Bulletin No. 2004-08

25 HP (2-Stroke) EPA Decal - Incorrect Information

a - EPA decal

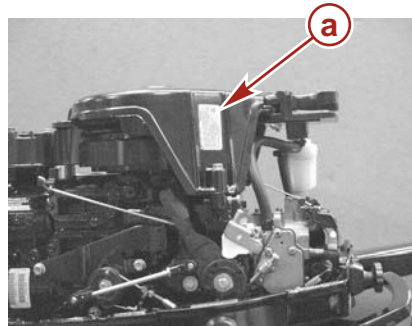
The EPA decal for the 25 HP engines listed the incorrect FEL information. The correct FEL number is 192.05 g/kWh.

1. Remove the engine cover.
2. The decal is located on the rewind starter housing as shown in the picture.

The problem was identified and the decal was corrected starting with serial number OT851666. To rectify this problem, the corrected EPA decal should be applied over the existing decal according to the following instructions.

a - Location on decal indicating the months of the year

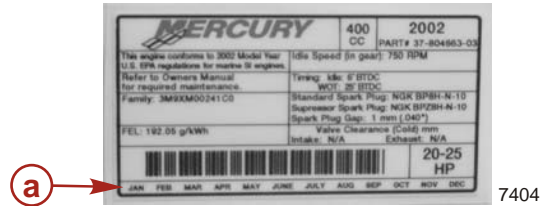
- Note the month on the original decal. Using a scissors or a hole punch, notch the same month on the new decal.

- Clean the surface of the original decal containing the incorrect information using rubbing alcohol or equivalent.
- Apply the new decal directly over the original decal on the rewind starter housing.
